# HERD Test Beam 3D Model Review

14/04/2023

- Issue #01

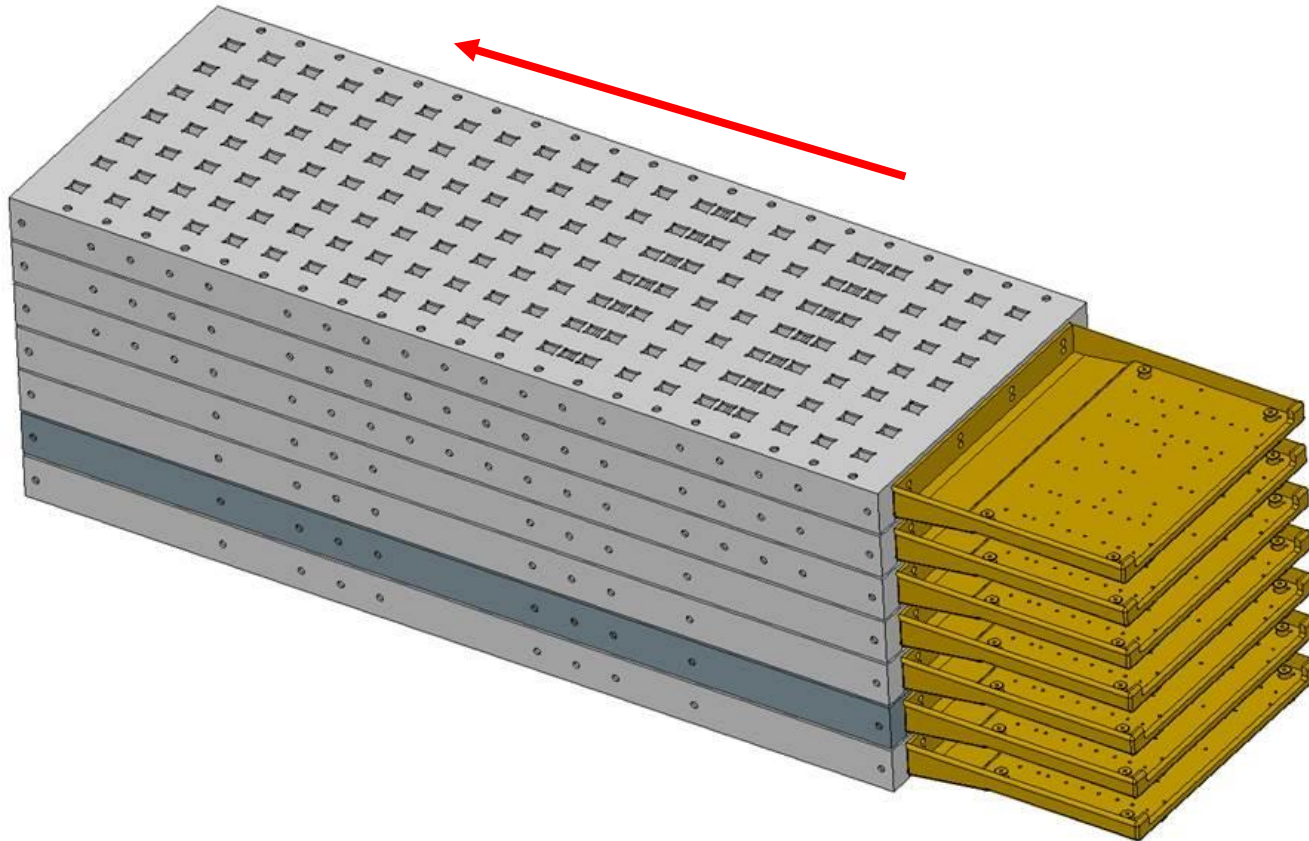
The blind diodes are in the nearest part of the TROC2 board.

They should be in the opposite side. @Lorenzo

# • Issue #02

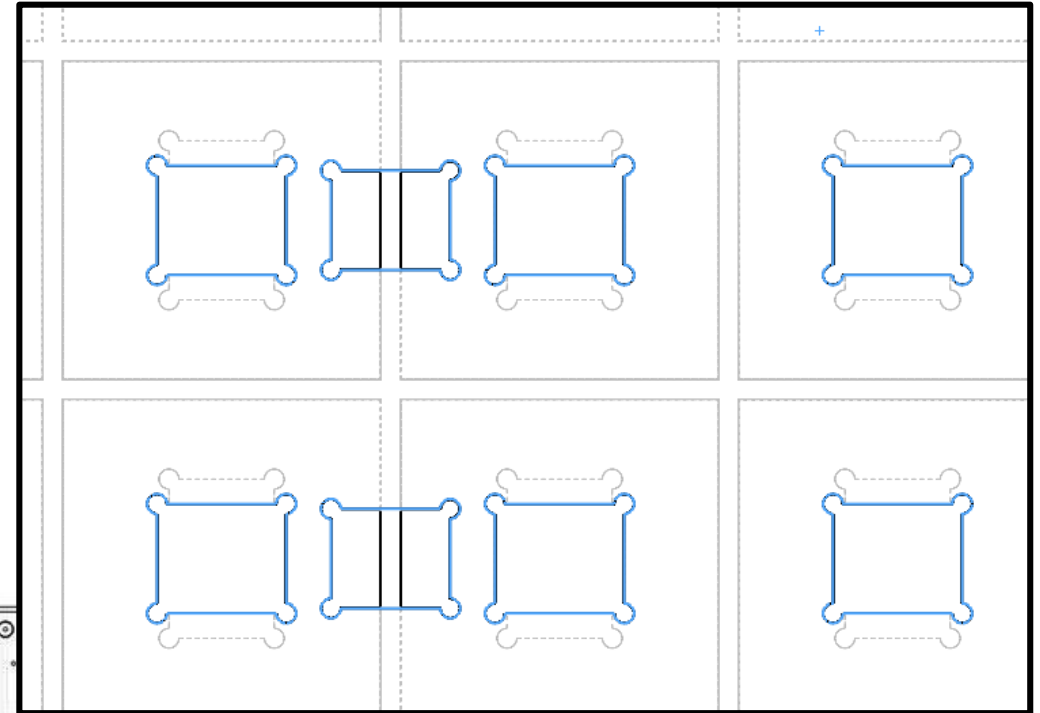
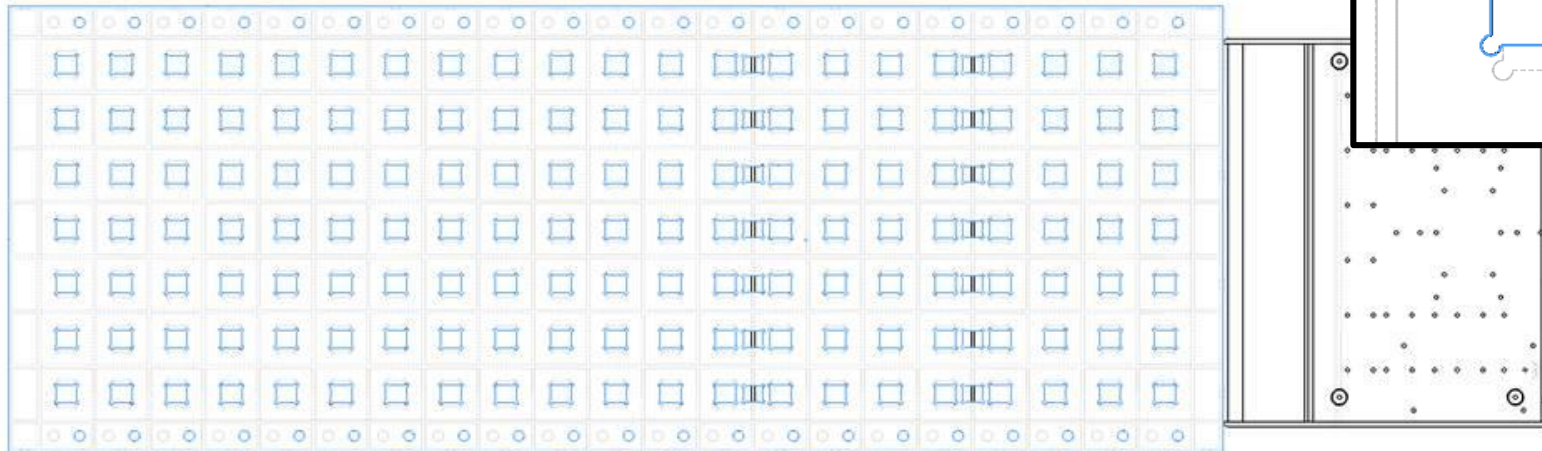
Holes for PD sensors are in different orientation depending on the tray. Blue is top tray, dashed line for other trays.

PD holes: the orientation must be always the same, the long side of the PDs must be parallel with the kapton cable. @Lorenzo

# Issue #03

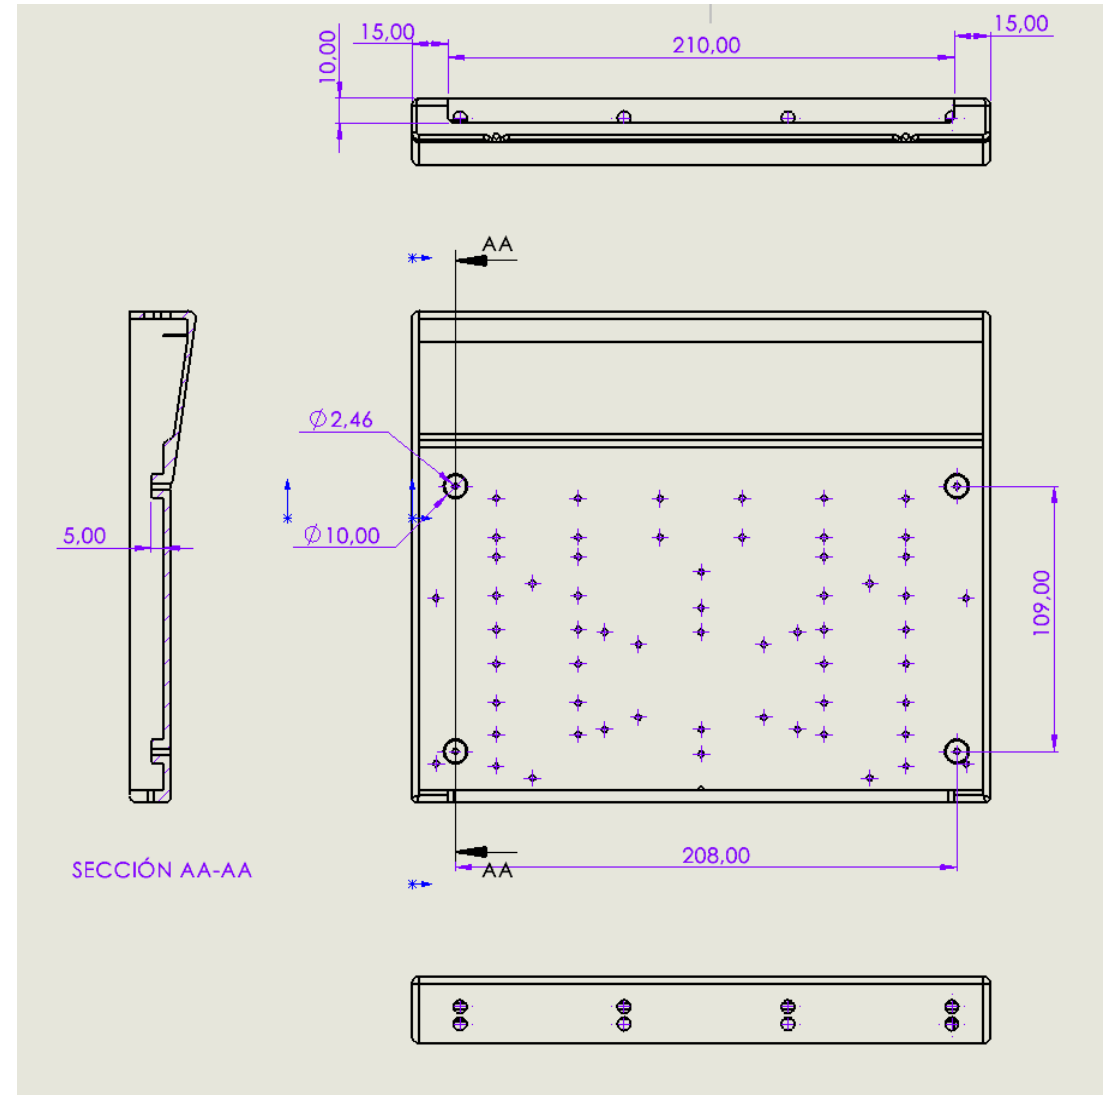
Towers for the interface between TROC2 and Frame are 10 mm diameter and 5 mm height.

They should be all 6 mm diameter maximum in order to avoid interferences with some components. @Jesus Marin

# Issue #04

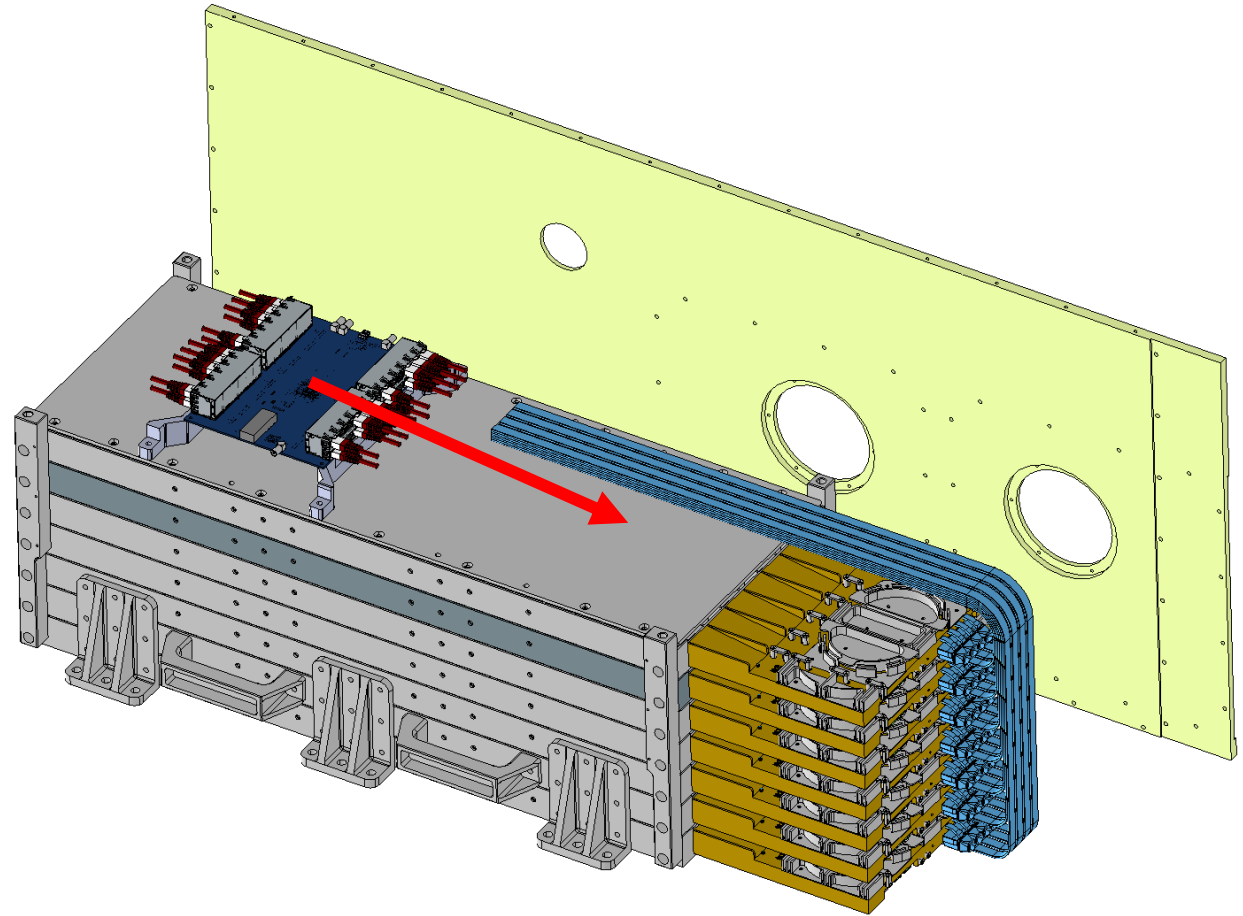
TROC1 not included in the current 3D model.  
Moving TROC1 closer to the TROC2.

We propose to move the TROC1 board closer to the TROC2 in order to fit cable length.  
We propose to include TROC1 3D model and we will provide the new location.

# • Issue #05

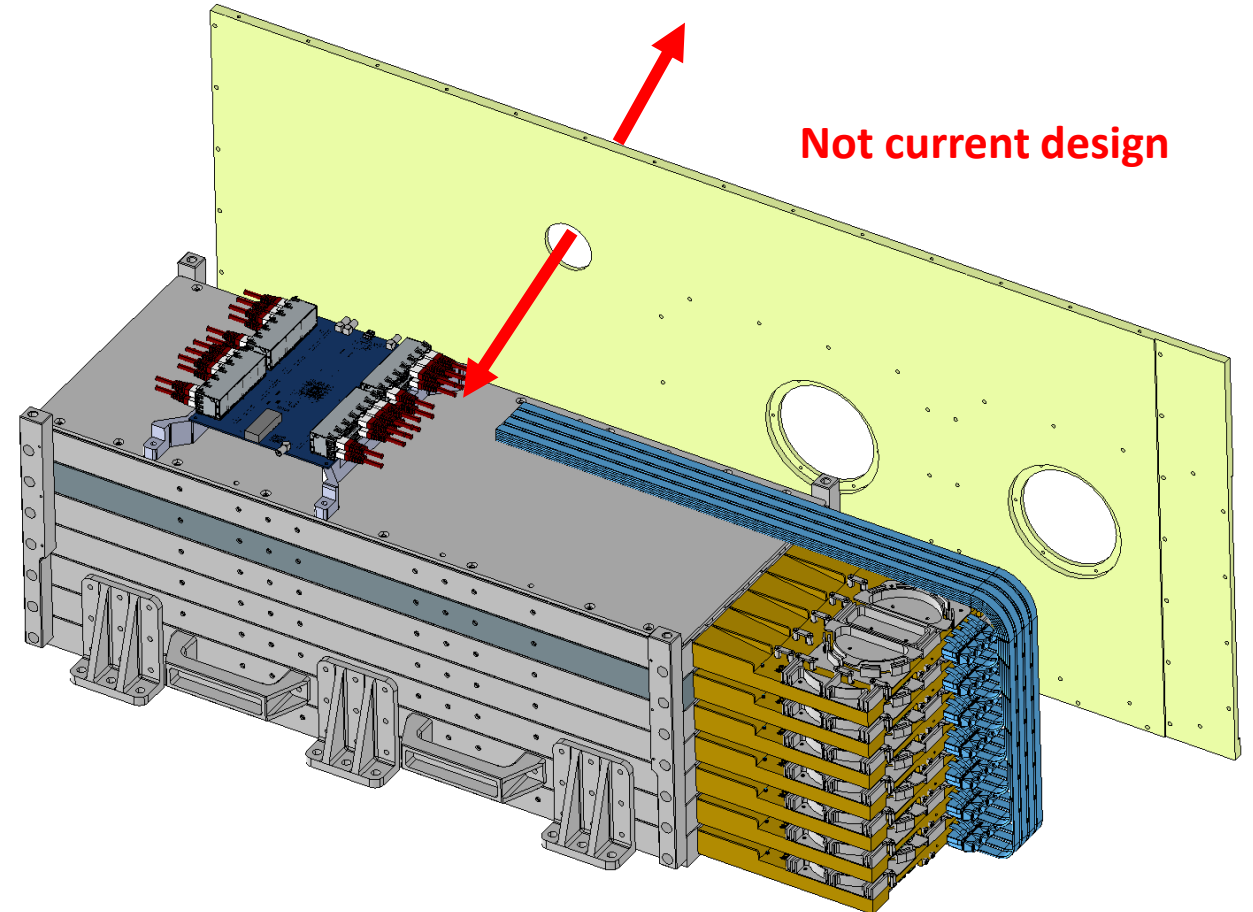
Cabling feedthrough not included in the current 3D model.

- In 2021 SPS test beam cables from TROC1 and TROC2 exit the black box through a 50mm circular hole in the lateral wall.
